**STAFF RECOMMENDATION**  
**2502 Barton Avenue**  
**November 18, 2015**

**Application:** New construction - addition  
**District:** Hillsboro-West End Neighborhood Conservation Zoning Overlay  
**Council District:** 18  
**Map and Parcel Number:** 10411015200  
**Applicant:** Jeff Steele, Architect  
**Project Lead:** Sean Alexander, sean.alexander@nashville.gov

**Description of Project:** The applicant proposes to enlarge a one-story contributing building with a two-story rear addition.

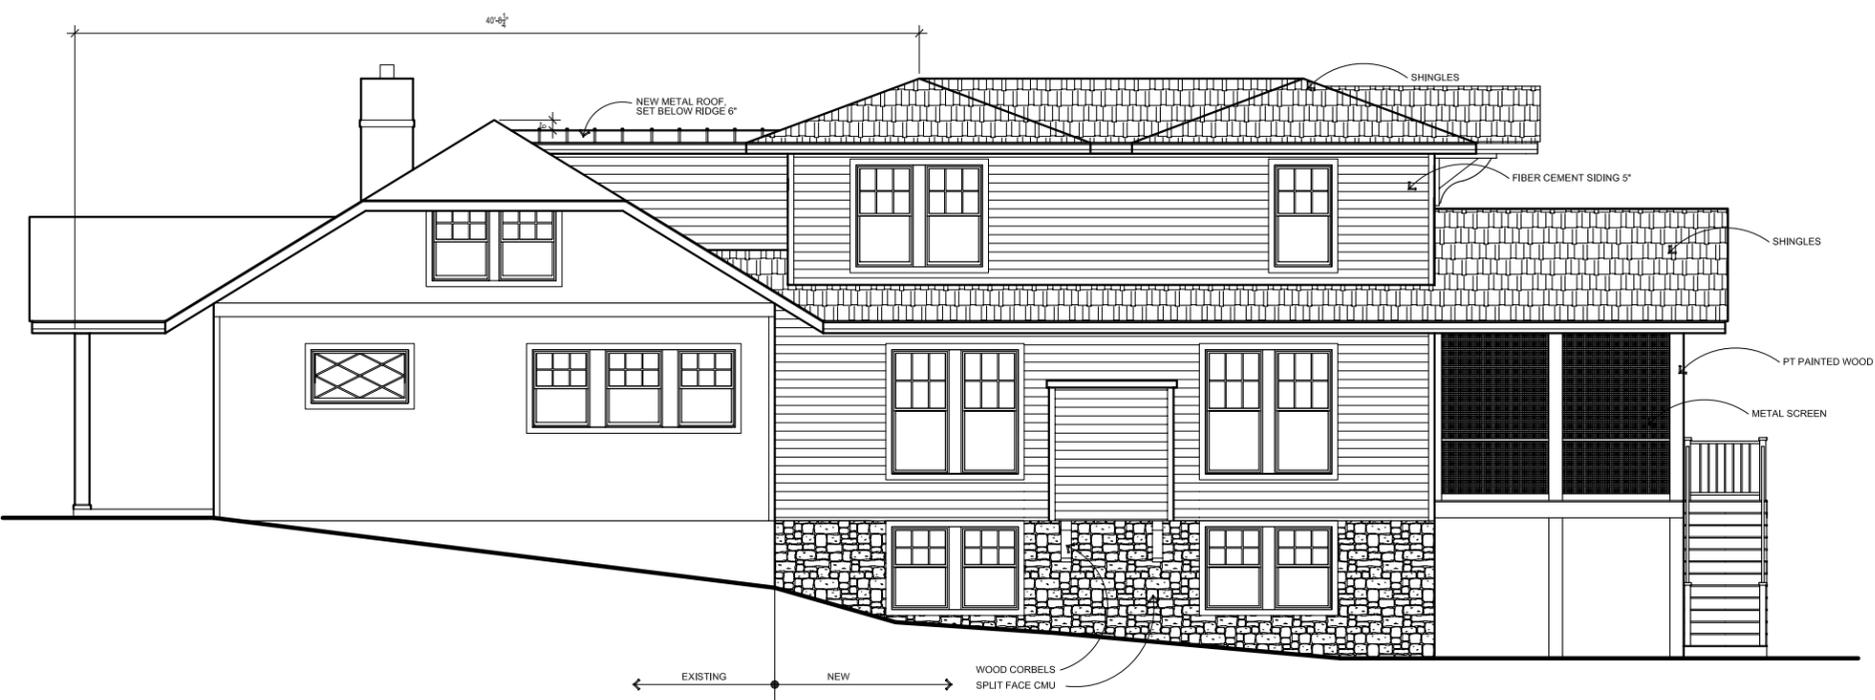
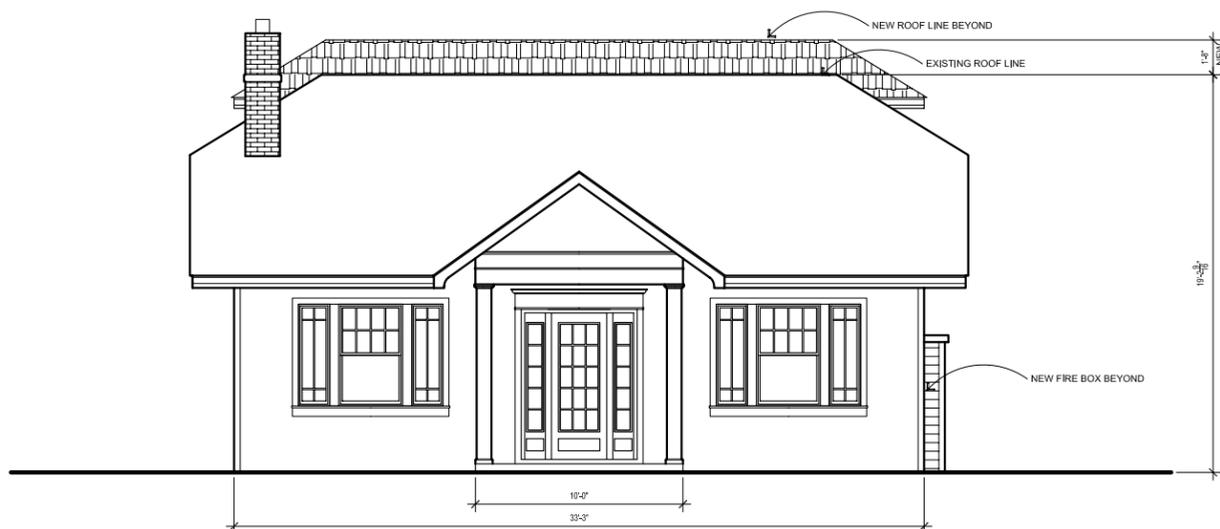
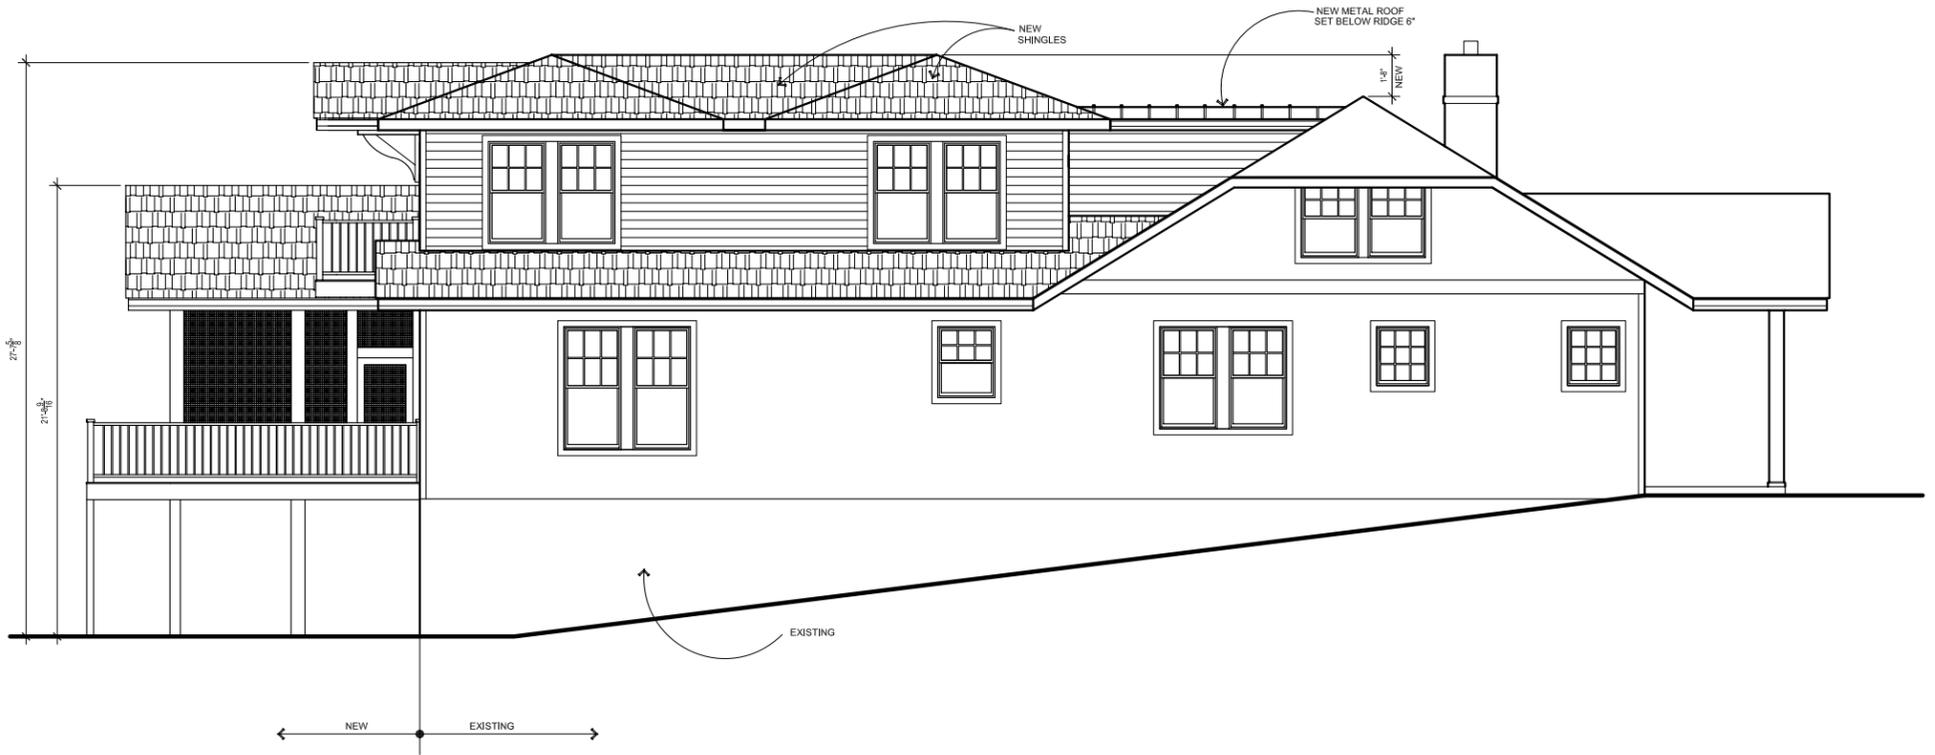
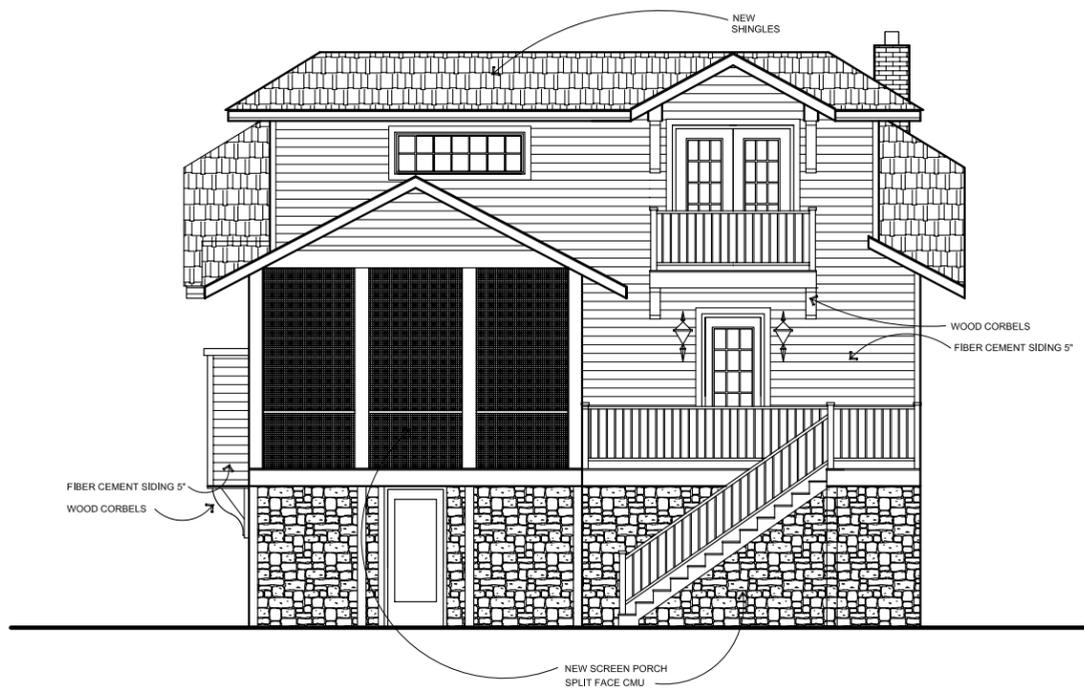
Height & Scale: The addition will be at the rear of the existing building, tying into the ridge of the house and extending back twenty-feet (20'), then rising to a peak twenty inches (20") taller than the historic house. The upperstory walls will be stepped in two feet (2') from the existing side walls, and the gable ends of the new roof will be clipped. Staff finds that despite being taller, the distance from the front of the house and stepped-in side walls help to minimize the visibility and impact of the addition. Staff finds the project to meet sections II.B.1.a and II.B.1.b of the design guidelines.

Roof form: The primary roof of the addition will be a complex hipped roof with clipped gable-ends, matching the form of the original roof. The new roof will have sections with different pitches including 5:12, 6:12, and 8:12. From the perspective of the right of way, these roofs will not contrast with the 8:12 pitch of the original roof. Staff finds the project to meet section II.B.1.e of the design guidelines.

Proportion and Rhythm of Openings: No changes to the window and door openings on the existing house were indicated on the plans. The windows on the proposed addition are all generally twice as tall as they are wide, thereby meeting the historic proportions of openings. There are no large expanses of wall space without a window or door opening. Staff finds the project's proportion and rhythm of openings to meet Section II.B.1.g.
